VIRGINIA ELECTRIC AND POWER COMPANY
SURRY POWER STATION UNITS 1 AND 2
PROPOSED TECHNICAL SPECIFICATION CHANGE
AUXILIARY FEEDWATER REQUIRED ACTION STATEMENT REVISIONS

TSCR – AFW Required Action Statement Revisions

Attachment 1
Discussion of Change

Marked-up Technical Specifications Pages

AUXILIARY FEEDWATER FLOW DIAGRAM

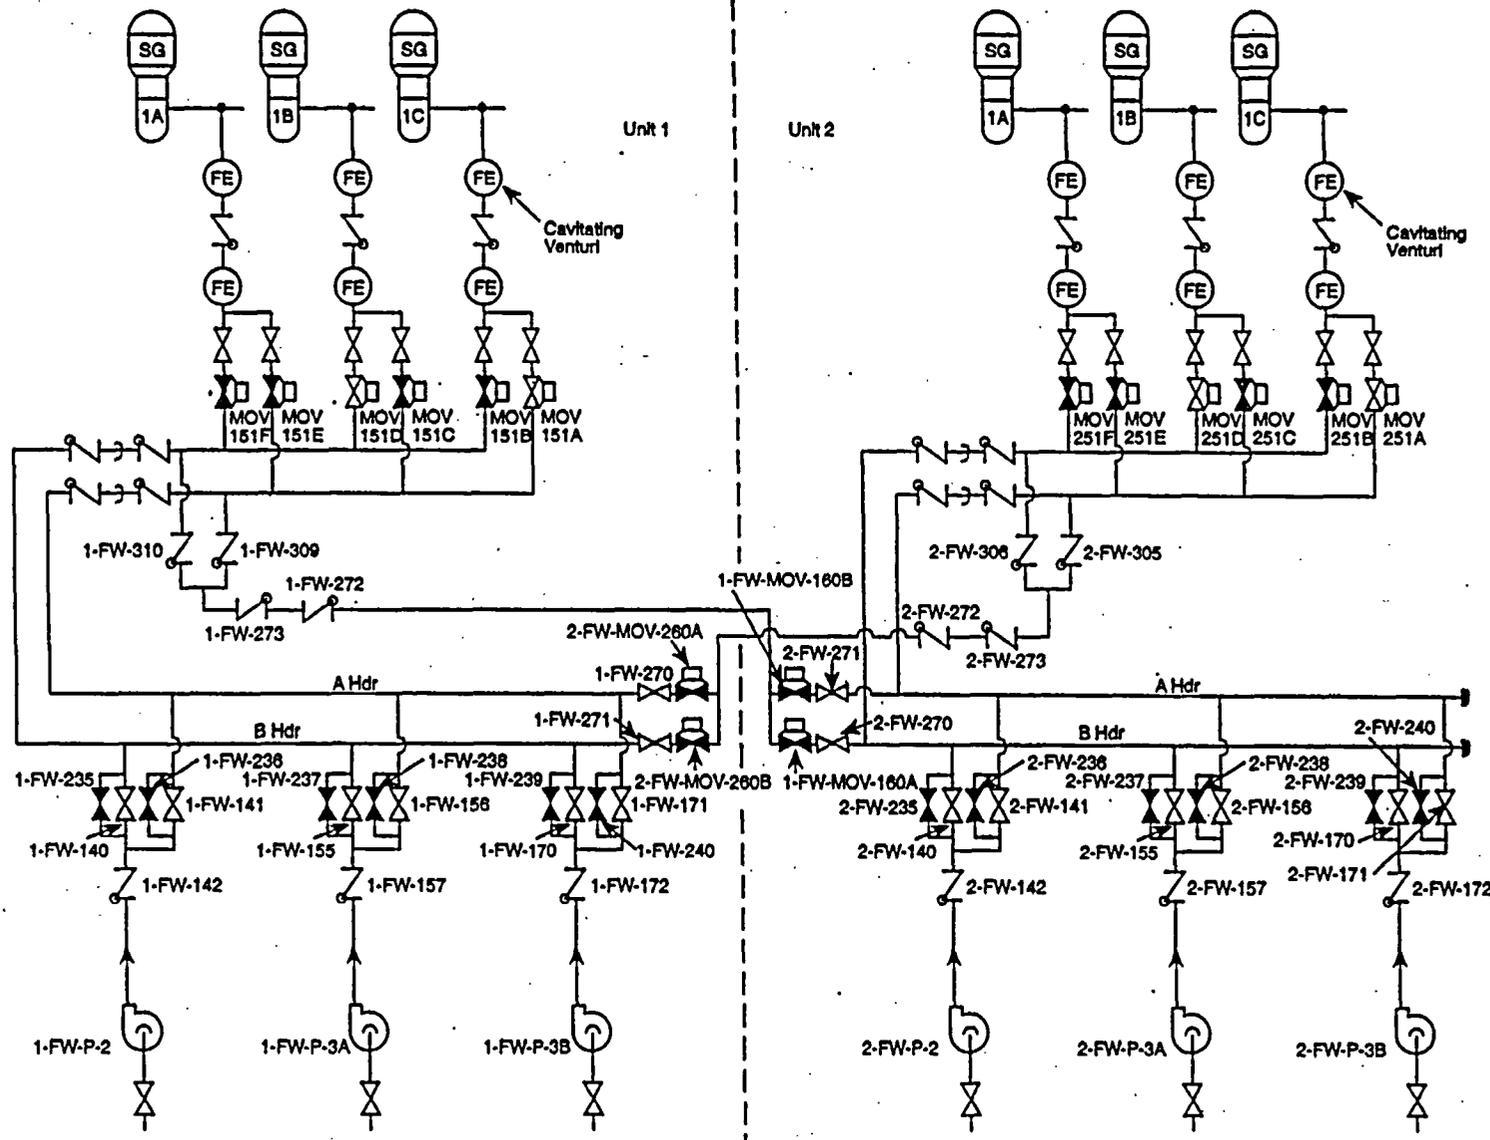
The AFW System for each unit consists of two motor driven AFW pumps each rated for 350 gallons per minute (gpm) at 2730 feet of head, one steam driven AFW pump rated for 700 gpm at 2730 feet of head, a 110,000 gallon emergency condensate storage tank, and associated piping, headers, valves, controls, and instrumentation. A flow diagram is included to illustrate the AFW System configuration. Use of two motor driven AFW pumps and a steam driven AFW pump provides for diversity of power sources for the automatic actuation of the AFW supply. The AFW pumps, powered by either power source (i.e., motor driven or steam driven), provide adequate capacity to cool the reactor coolant system (RCS) when required. The amount of AFW flow that is required is dependent upon the amount of decay heat being generated, the rate of cooldown desired for the RCS, and the heat being added to the RCS by operating reactor coolant pumps. Although the flowpaths from the pumps to the steam generators include common piping, the configuration of the system provides two redundant flowpaths. The components in one flowpath are supplied by the H emergency bus, while the other is supplied by the J emergency bus. The AFW Systems for Units 1 and 2 are cross-connected to provide additional redundancy in case a single event, such as a fire or a high energy line break in the main steam valve house, would disable the AFW System on one unit.
